**AMENDMENTS TO THE DRAWINGS:**

### **REMARKS**

FIG.1

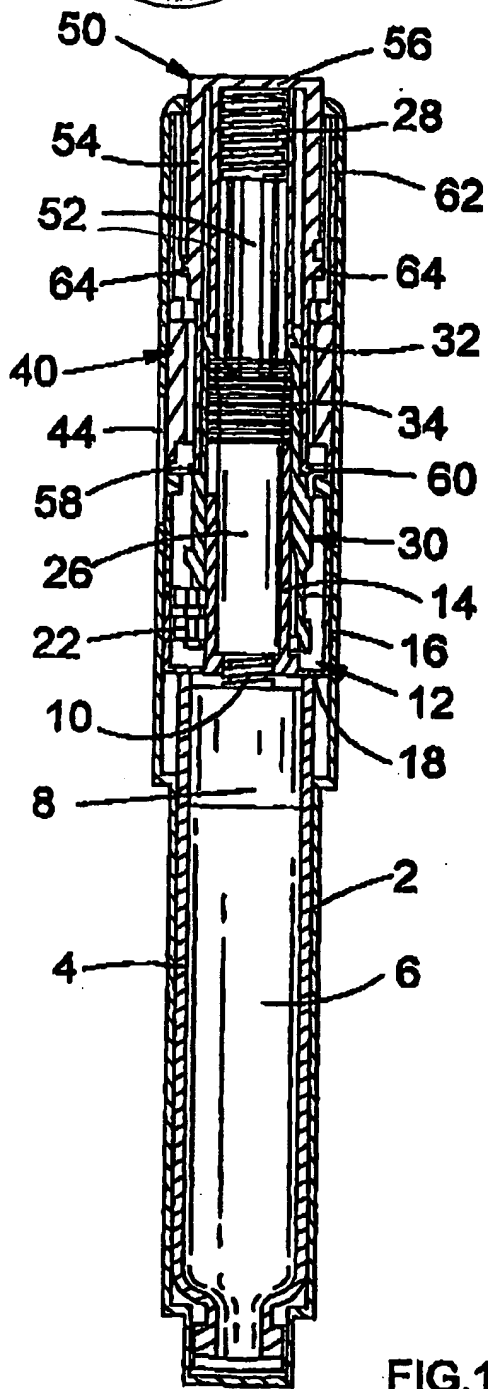
The attached replacement sheet of drawings include the following changes to the drawing figures: FIG. 1 is amended to properly indicate the first cylinder 52, which is described on page 10, lines 14-26 of the originally filed application. Accordingly, Applicants submit a replacement sheet and an annotated sheet showing the drawings changes to FIG. 1.

ANNOTATED MARKED-UP DRAWING
